Model: DI-C1.5	Date: 15-Dec-10	No.: RD104001d
----------------	-----------------	----------------

Subject: Firmware Release Note: Engine		Prepared by: R. Takemura	
From: 1st Tech Service Sect., MFP/Printer Tech Service Dept.			
Classification:	<input type="checkbox"/> Troubleshooting <input type="checkbox"/> Mechanical <input type="checkbox"/> Paper path <input type="checkbox"/> Product Safety	<input type="checkbox"/> Part information <input type="checkbox"/> Electrical <input type="checkbox"/> Transmit/receive <input checked="" type="checkbox"/> Other (Firmware)	<input type="checkbox"/> Action required <input type="checkbox"/> Service manual revision <input type="checkbox"/> Retrofit information <input checked="" type="checkbox"/> Tier 2

This RTB has been issued to announce the firmware release information for the **Engine**.

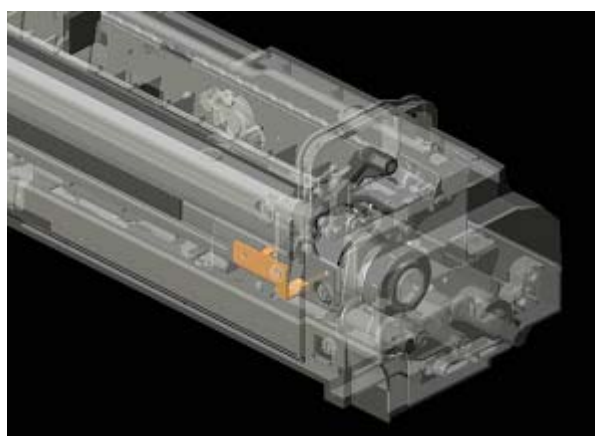
Offset images occur at 95mm intervals.

The discharge brush is not reattached to the fusing unit after the cleaning roller option is replaced. As a result, the toner charges the surface of the pressure roller.

When you replace the cleaning roller option (***D1054380***):

- Make sure to remove the discharge brush from the fusing unit first, and then reattach it after installing the new cleaning roller option.
- Make sure the discharge brush is secured to the bracket.

Not to forget to reattach the discharge brush, it is added to the cleaning roller option.

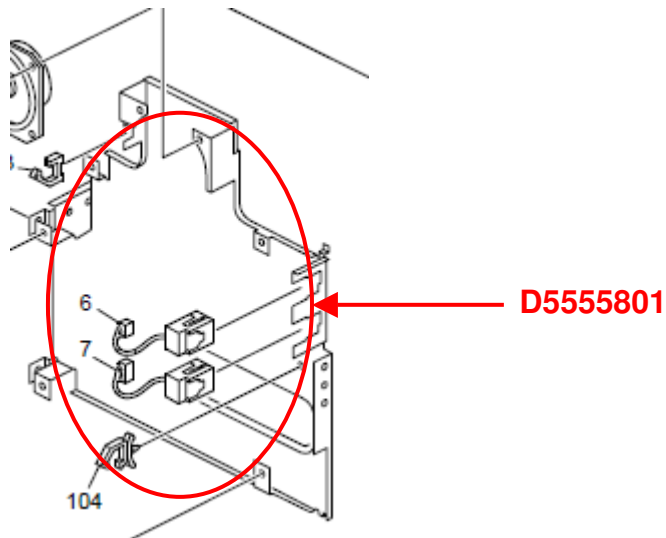
Change/Reason: The part shown below was missing from the Parts Catalog.

Old part number	New part number	Description	Q'ty	Int	Page	Index	Note
-	D5555801	Bracket: FCU	1	-	2	15

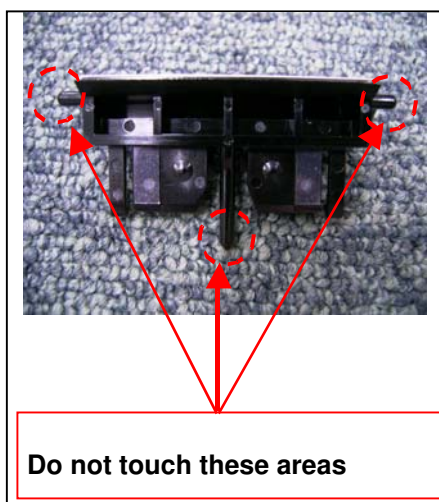
A quick-drying grease is applied to the paper tray (P/N D0392551) to make the contact with the paper tray more smooth.

If this symptom is reported, replace the friction pad with the following:

Important: When you replace the friction pad, make sure to handle the new part very carefully. Do not touch the areas shown in the photo below. This is to prevent the grease from getting on the surface of the feeding pad. If the grease sticks to the pad, a double-feed paper jam may occur.

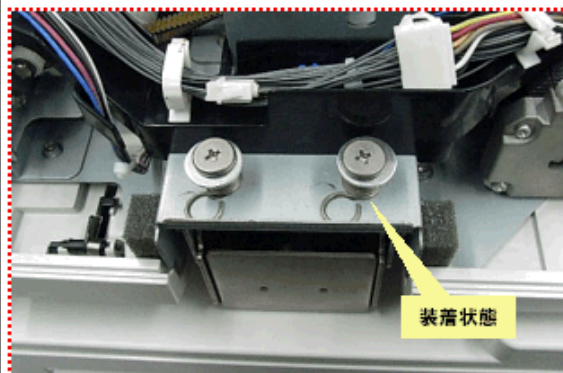
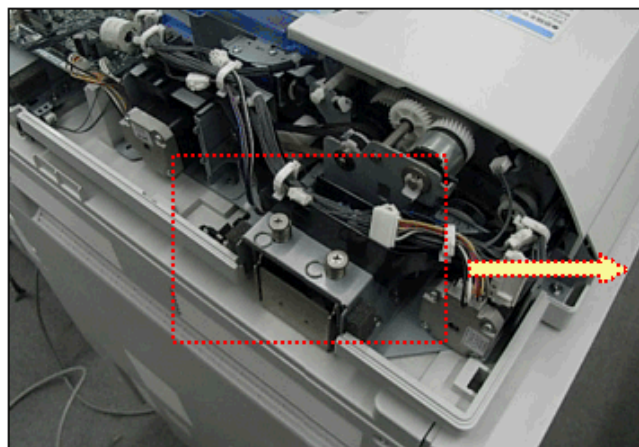
Torque of the hinge increases with time and it can create an imbalance in the pressure applied to the original between the front and rear sides of the ADF.

Remove the following stud screws and reinstall them with a white spacer (07080080N) under each screw.

Replace Hinge: Left (D3661271) with the new part (D5411271).

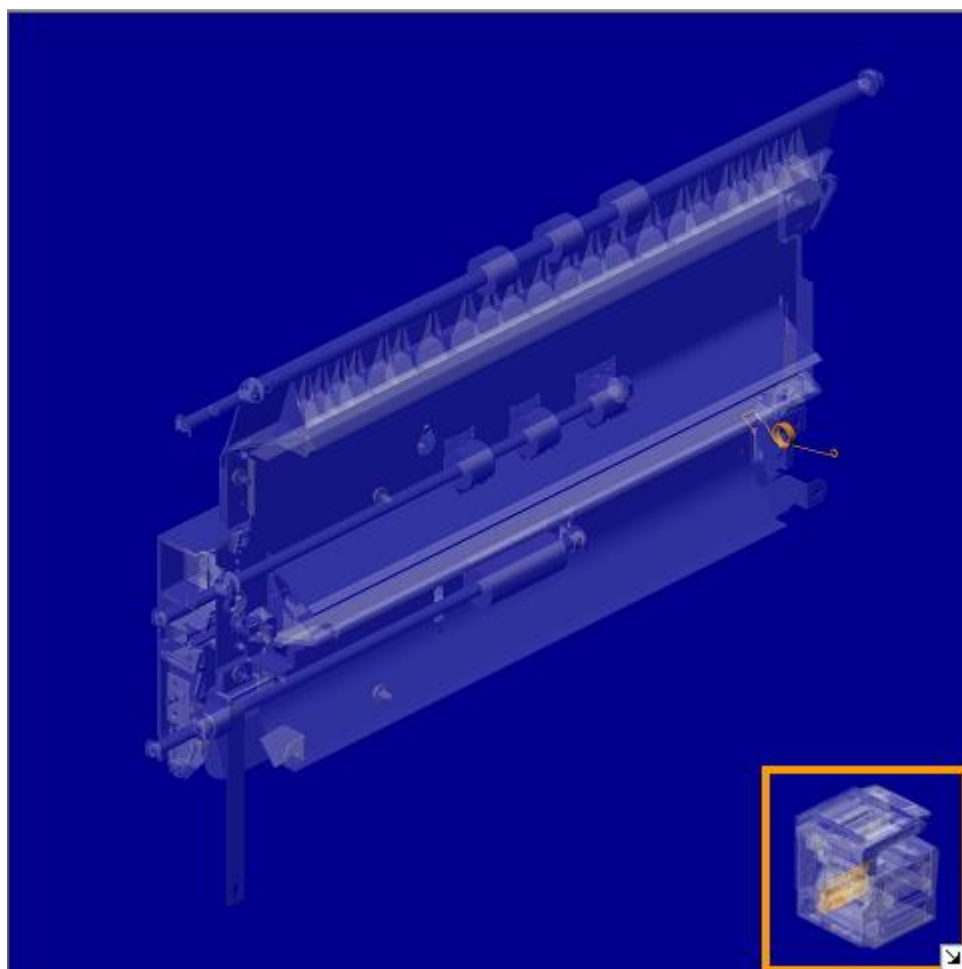
Reason
Ensure safety margin.

Old Part Number	New Part Number	Description	Q'ty	Int	Page	Index	Note
	D1052929	TORSION SPRING:VERTICAL TRANSPORT:GUIDE PLATE	1	-	39		Add
